# **BUILDING CODE OF AUSTRALIA 2022 ASSESSMENT REPORT**

**Project Name:** Residential Flat Building  
**Project Address:** 20 Heradale Parade, Batemans Bay  
**Date:** 3 September 2024  
**Project No:** 220192

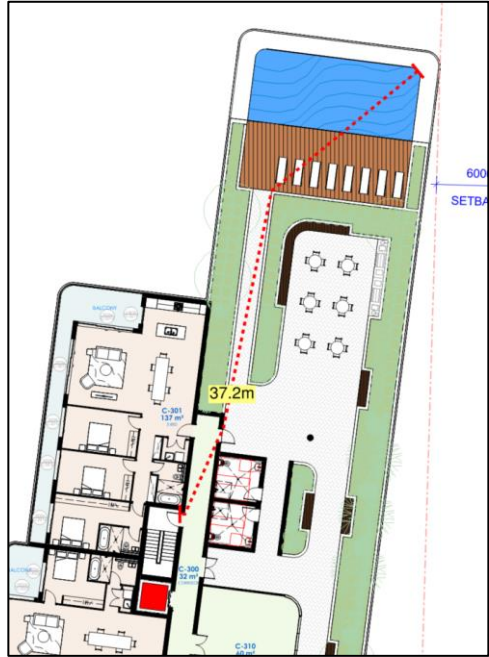
Clause	Design requirement	Compliance review
		<p>(1) Travel distance on the residential levels up to 12.2m in lieu of 12m to the exit from the following units:</p> <p>a. Level 1 - Unit B-104</p>  <p>b. Level 2 – Unit B-204</p>  <p><b>Building C:</b></p> <p>(1) Extended Travel distances measured up to 13.2m in lieu of 12m to the exit from the following units:</p> <p>b. Level 1 – Unit C-102</p>

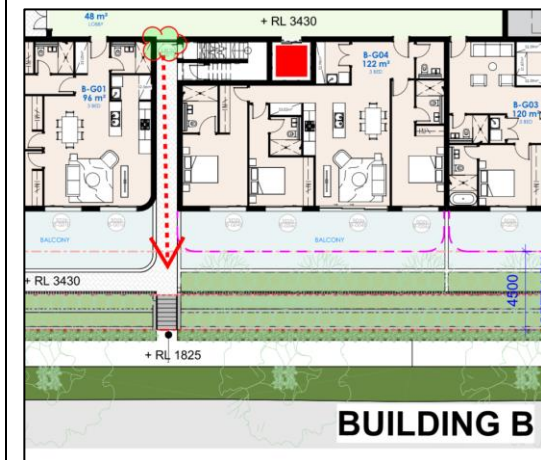
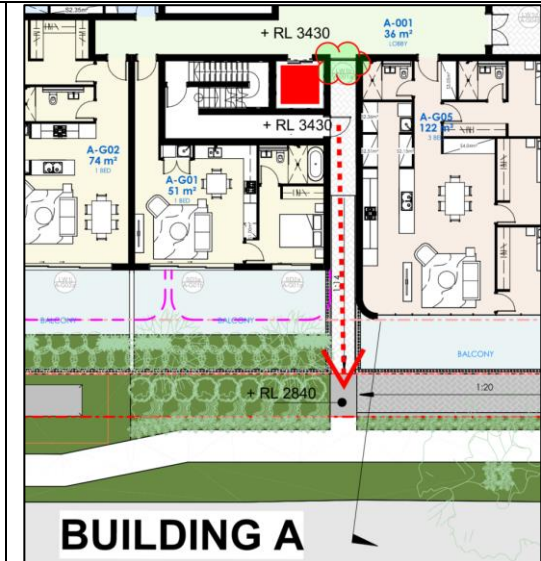
Clause	Design requirement	Compliance review
		 <p>(4) Travel distance on Level 2 pool maintenance room up to 38.1m in lieu of 20m to the exit:</p>

Clause	Design requirement	Compliance review
		 <p data-bbox="1485 962 2078 1018"><b>(5)</b> Travel distance on Level 3 pool up to 37.2m in lieu of 20m to the exit:</p>

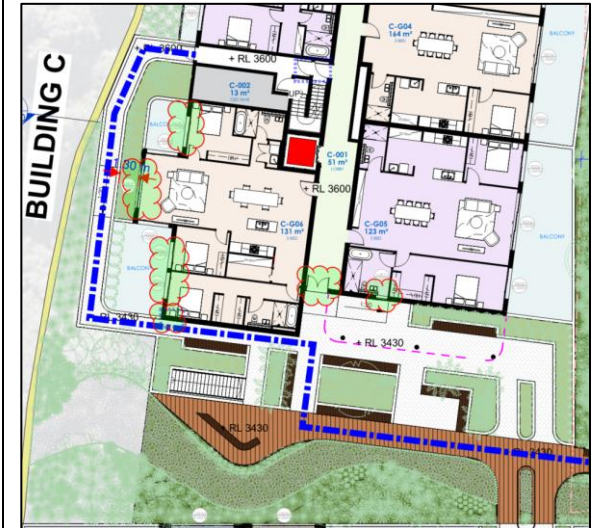
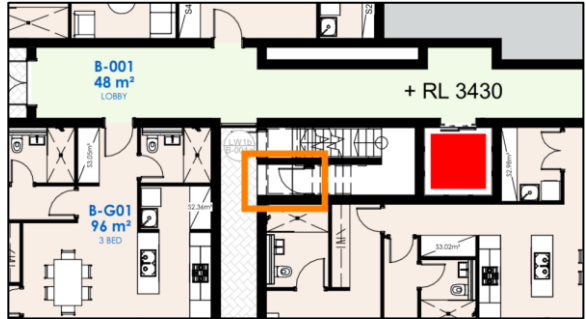
**Performance Solution Required:**

**Building C:**

(1) The path of travel from the point of discharge of the fire-

isolated stairway necessitates passing with 6m of the unprotected openings in the external wall of the building.

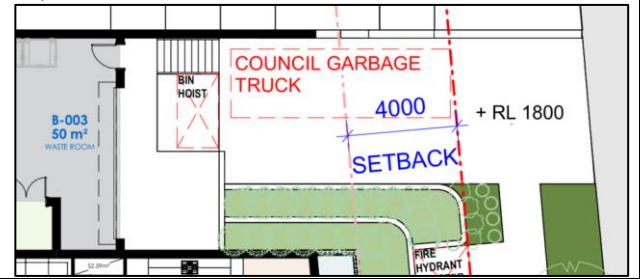
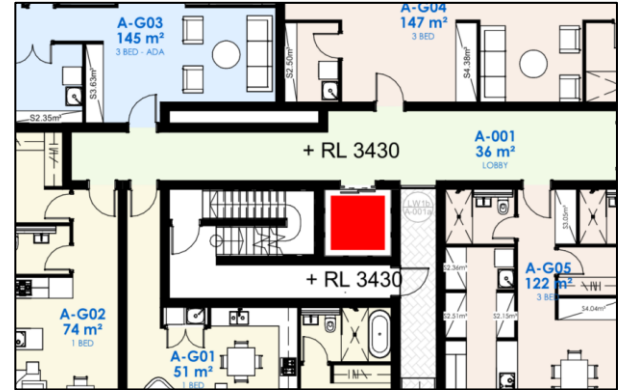
**Performance Solution Required:**

**Building B:**

The descending stair flight discharges internally into the building.
